Appl. No. 10/673,640
Amdt. Dated September 14, 2005
Reply to Office Action of March 16, 2005

Amendments to the Drawings:

REMARKS:

FIG. 8

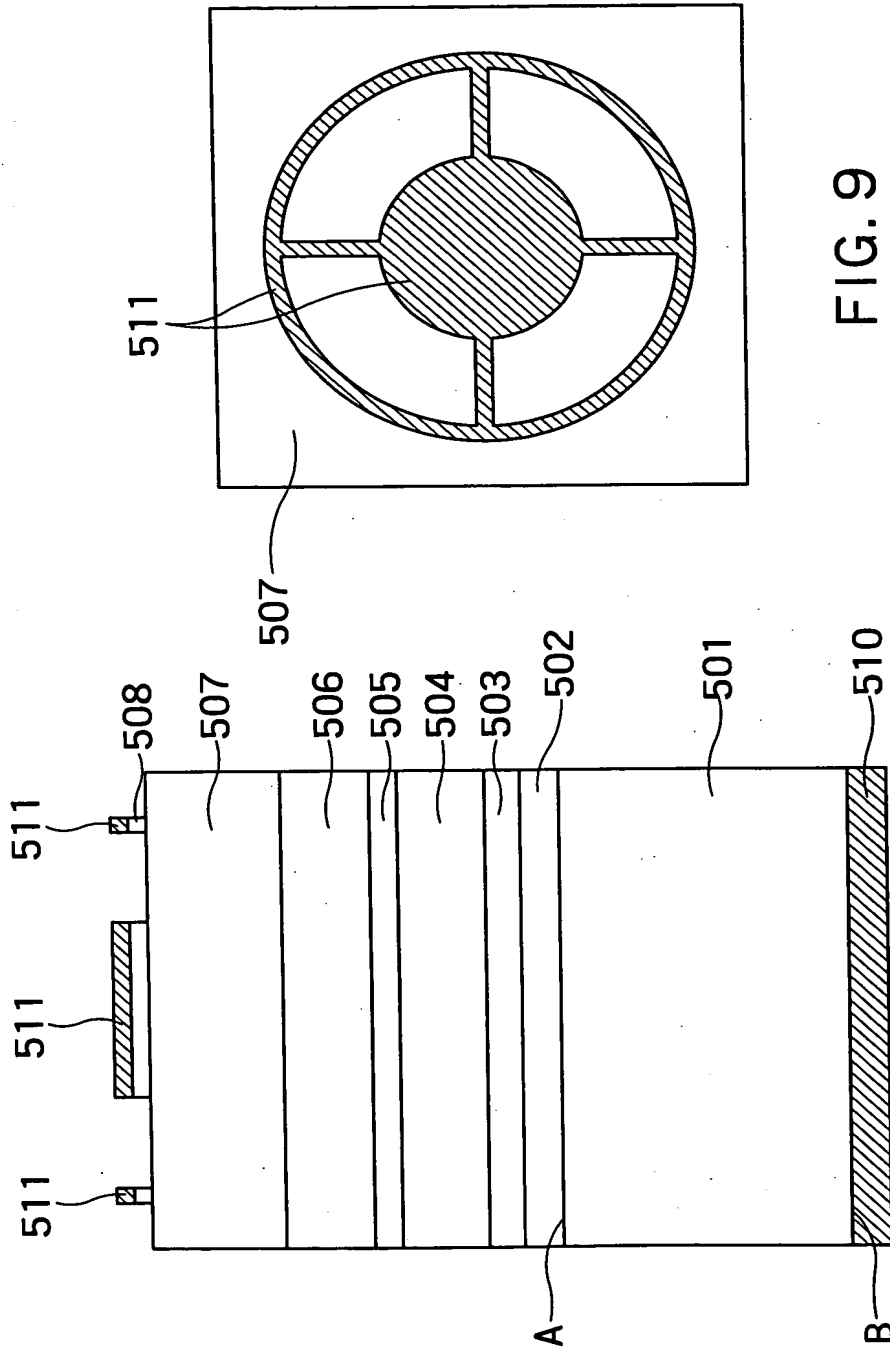
The attached sheet of drawings includes changes to FIGS. 8 and 9. This sheet, which includes FIGS. 8 and 9, replaces the original sheet including FIGS. 8 and 9. FIGS. 8 and 9 have been labeled as Prior Art as requested by the Examiner.

The Office Action objects to the drawings. Applicant attaches a sheet of drawings including changes to FIGS. 8 and 9. This sheet, which includes FIGS. 8 and 9, replaces the original sheet including FIGS. 8 and 9. FIGS. 8 and 9 have been labeled as prior art as requested by the Examiner.

Prior Art
